# Illustrated Parts List - IPL Update

**372 XP X-TORQ**

1. Incorporation of a new Oil pressure hose, Crankcase and Chain guide plate.  
Reason: Prevent poor oil distribution to the bar.

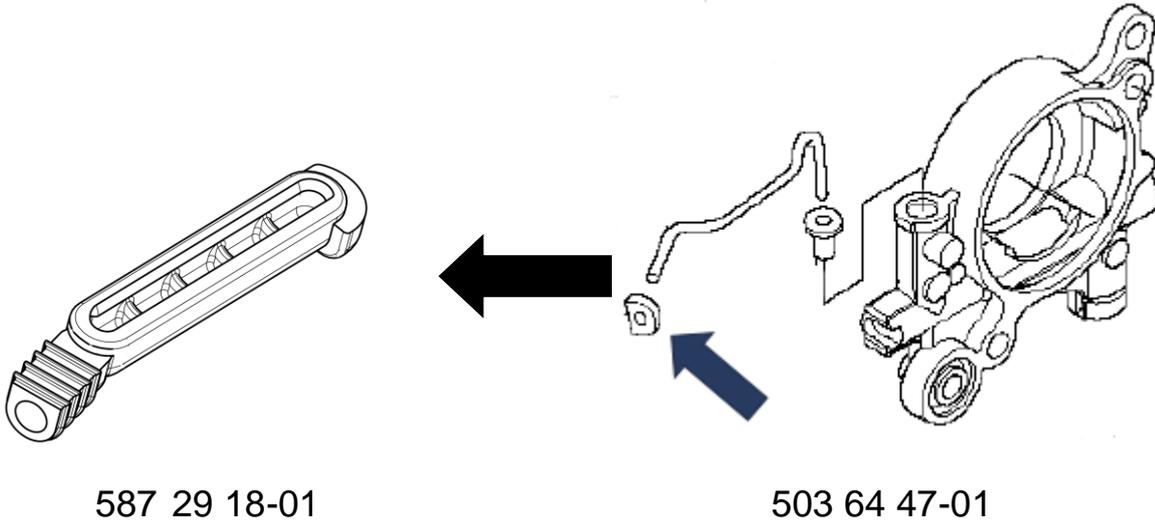
The new crankcase has a new slot in the bar pad area and the new chain guide plate has a slot that is adapted to the new oil pressure hose.

Therefore the new chain guide plate, screw and new oil pressure hose is included in crank case assy spare part 503 62 68-19.

Serial number / Date	Remark
20182100001 -	Oil pressure hose 587 29 18-01
20182100001 -	Chain guide plate 537 01 37-02

## 2. Crank case

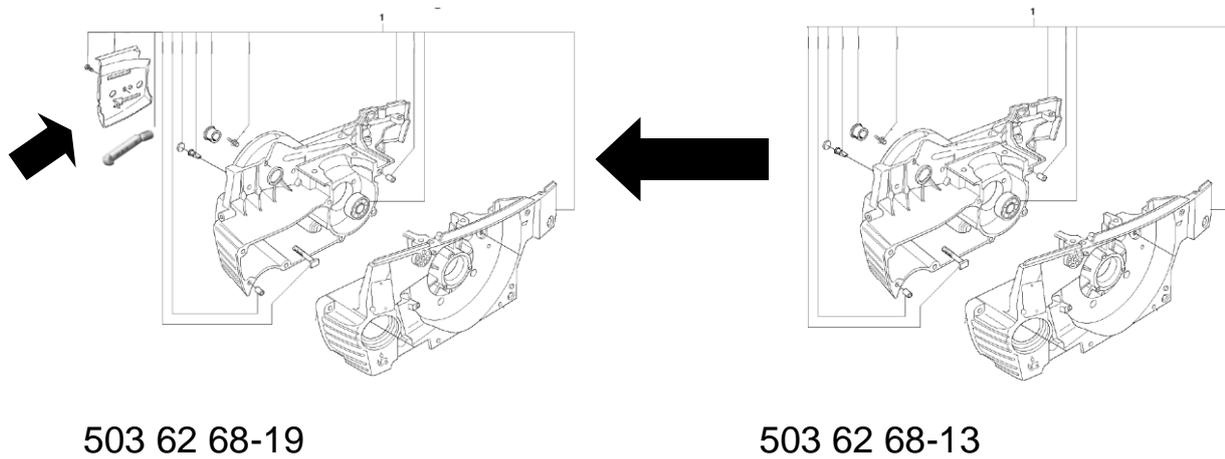
Page Title	Ref. No	New part no	Name	Excl. part no.	Remark
Clutch & Oil pump	13	587 29 18-01	Oil pressure hose	503 64 47-01*	*Remain as spare part
Crank case	1	503 62 68-19	Crank case assy	503 62 68-13	
Crank case	10	537 01 37-02	Chain guide plate	537 01 37-01*	*Remain as spare part

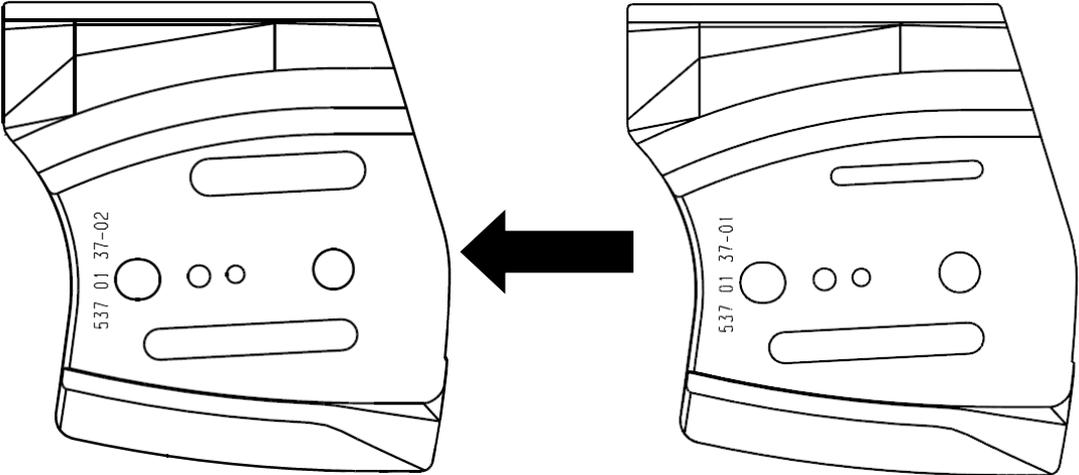
537 01 37-02

537 01 37-01
